_	Case No.:	
Fee: \$750.00	MAR 2 8 2023	Date File	l:
	Zoning Board of Ap Village/Town of Mount		
	Village/Town of Mo		
	Municipal Buil		
	104 Main Street, Mt. Kiso	co, NY 10549	
	Zoning Board of A		
	Application	1	
Appellant: DP 21, LLC			
	ford Road, Suite 145, Moun		
Address of subject proper	rty (if different): 333 Nor	rth Bedford Road, M	ount Kisco, NY 1054
Appellant's relationship t	to subject property: X	Owner Les	ssee Other
Property owner (if different Address:	ent): Same as above		
	ZONING BOARD OF AP Building Inspector, <b>Peter</b>		
dated 09/06/2019	. Application is hereby	made for the follow	ving:

WITHIN 1,470± SF TELECOMMUNICATIONS

SITE 180 S. BEDFORD RD. ADDRESS: MT. KISCO, NY 10594

C-6 SCALE: N.T.S.

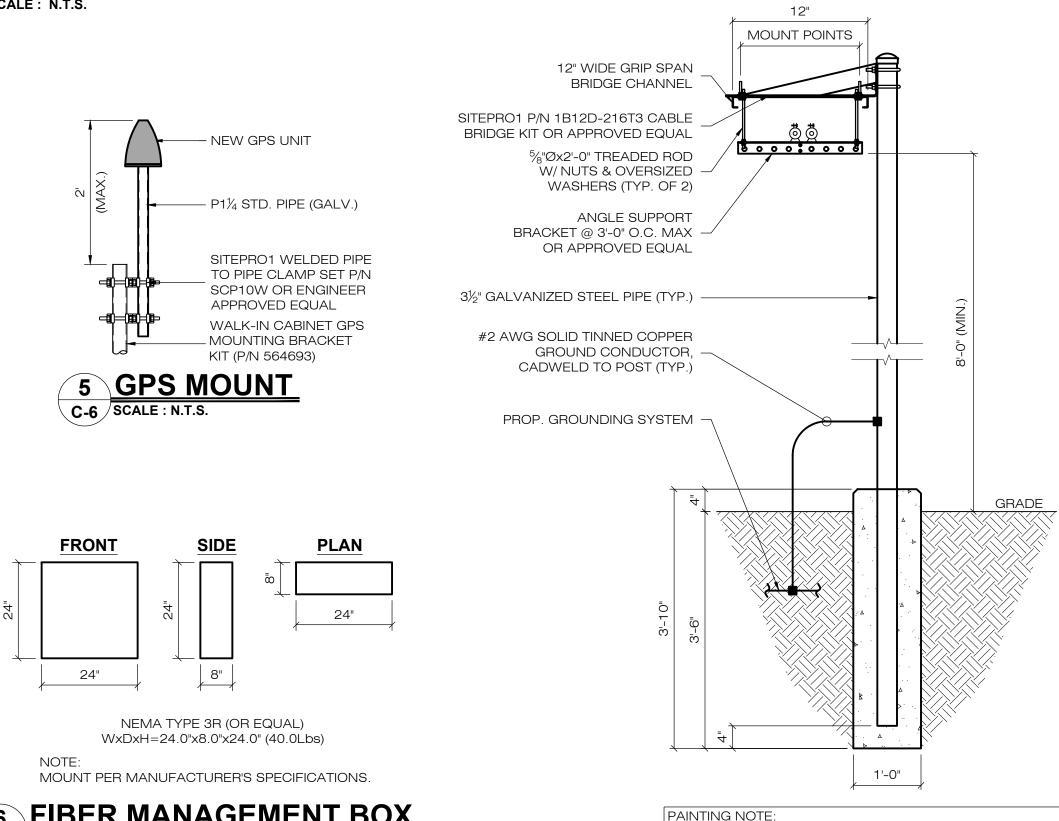
- Add note The equipment cabinet canopies and ice bridge shall be treated as a dark brown to match the compound fencing color
  - The drawings have been revised to specify that the proposed equipment canopies and ice bridges are to be painted dark brown (see Drawings C-1 and C-6).

Copy above generator notes to this sheet.
 A note regarding the proposed generator testing/cycling have been added to Detail 8 on Drawing C-1 and Detail 4 on Drawing C-6.

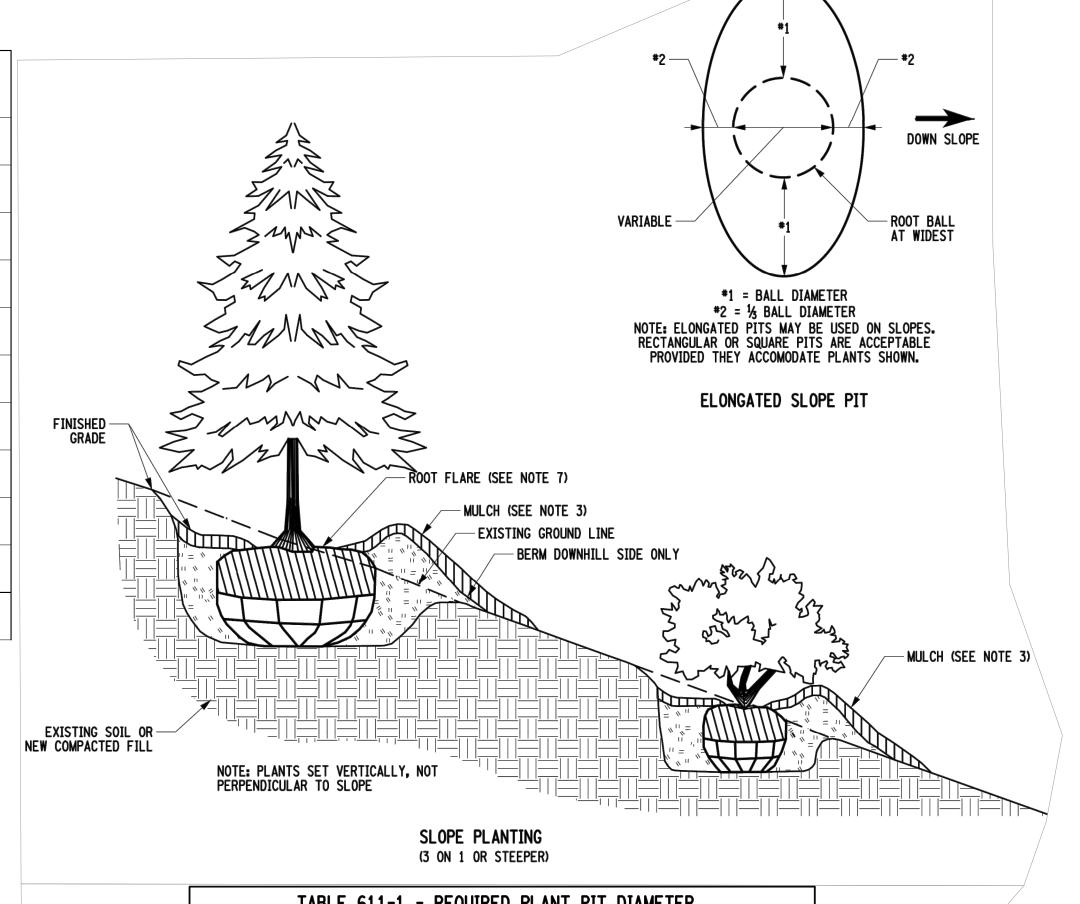
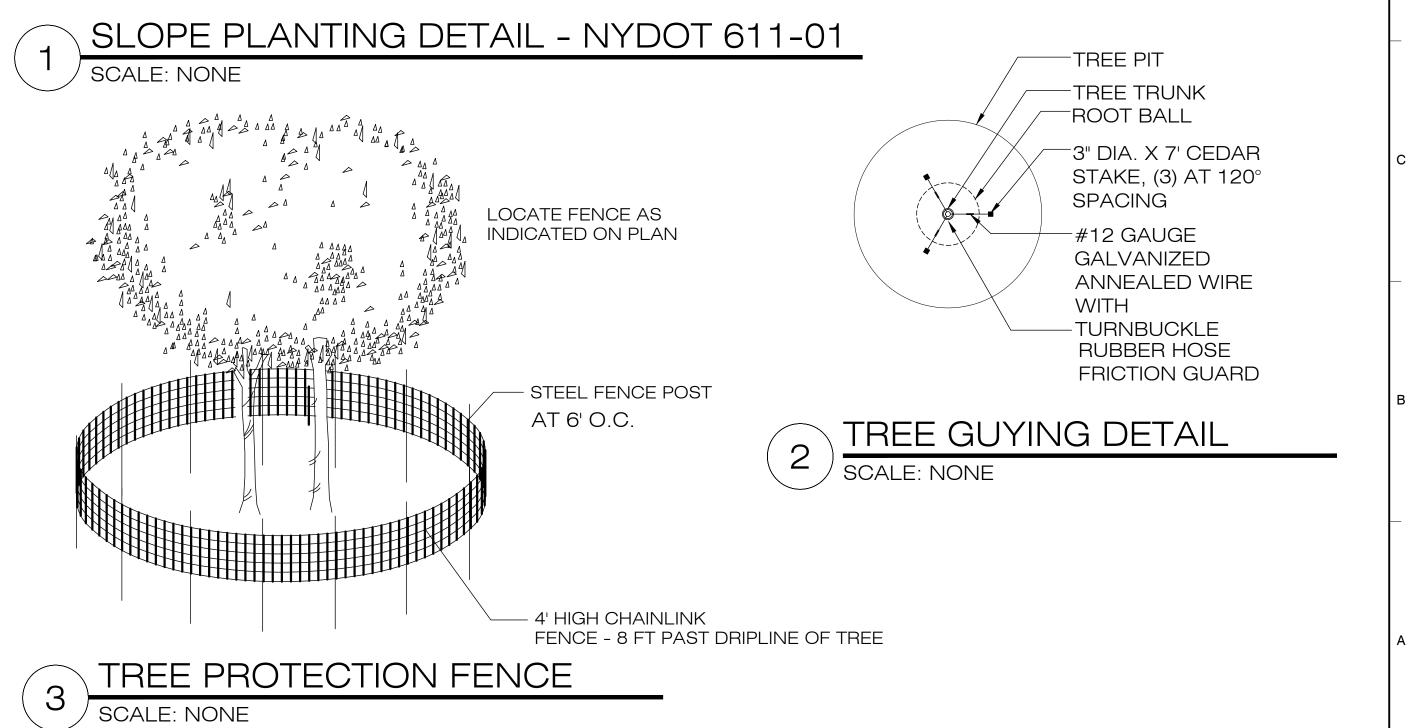
- Import details from EC-2. Evaluate preservation of additional existing trees per mitigation memo. Add notes describing tree protection details.
  - The proposed details and notes in regard to tree protection have been added to Drawing L2.

- Construction sequencing notes have been added to Drawing L2.
- Add note on bond / warranty to be furnished and commitment to maintain all on-site tree preservation and on-site plantings for the life of the facility. Homeland Towers shall maintain all landscaping for as long as the telecommunication site is on the property. Required maintenance shall include watering and replacement of on-site dead and/or dying landscaping.

- A bond/warranty note has been added to Drawing L2.
- Only physical means to control grass, weeds, or nuisance vegetation shall be used. The use of herbicides, pesticides, or other chemical means to control vegetation shall not be permitted at any part of the Homeland lease during construction and over the life of the facility.

- A grass/weed control note has been added to Drawing L2.
- Add note Tree removal associated with construction will need to occur between November 1 and March 31 to comply with the NYSDEC guidance for bat species.

A Tree Preservation Plan containing a note referencing Chapter 99 of the Village Code has been added to the Drawing set (Drawings L1 and L2).

A note has been added to Drawing L2.
